August 7, 1984

NED-84-397

NRC DOCKETS 50-321, 50-366  
OPERATING LICENSES DPR-57, NPF-5  
EDWIN I. HATCH NUCLEAR PLANT UNITS 1, 2  
SUPPLEMENT TO SUBMITTAL OF SPDS INFORMATION

Figure 1

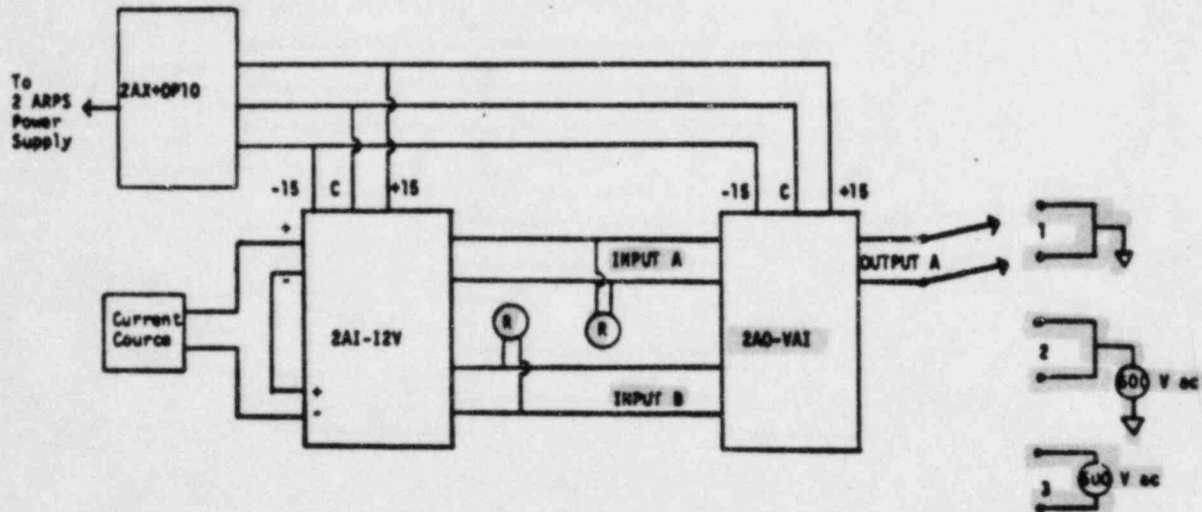
Question: What is the pass/fail acceptance criteria for tests on the SPDS isolation devices? This information was requested in question 2.3.d of the NRC request for information dated April 23, 1984.

Results of testing in which faults were applied to the outputs of the isolation device are contained in Foxboro test report QOAB44. Refer to page 14, Figure 1 for the test configuration. Applied faults and the corresponding equipment responses are listed on pages 11 and 12. Test results show no significant disturbance at the input in response to grounding of both outputs (reference Figure 2), and no significant disturbance at the input in response to application of 600 VAC across the outputs of the isolation device (reference Figure 4). Noise equivalent to 8% of full scale was observed on one channel when 600 VAC was applied from ground to both outputs of the isolation device (reference Figure 3). Note from the test configuration that the noise was measured at the output of the device's current-to-voltage converter, a circuit which also functions as an isolation device. The converter would prevent noise from propagating into the class 1E instrument loop. Based on these test results, and the fact that the worst credible fault in the SPDS results in 50 volts at the output of the isolation device, we conclude that Class 1E instrument loops are adequately isolated from the SPDS.

Response: Pass/fail acceptance criteria and results of qualification testing of the SPDS isolation devices are contained in Foxboro documents QOAAAO4 (Attachment 1), and QOAB44 (Attachment 2). We have obtained permission from Foxboro to transmit these documents to the NRC for the purpose of licensing the SPDS/ERF information system.

Acceptance criteria for qualification testing are listed on page 4 of test report QOAAAO4. There are no explicit acceptance criteria provided for performance of the isolation devices in response to faults applied to the outputs. However, the isolation devices were determined to be adequate for isolating Class 1E instrument loops based on the following:
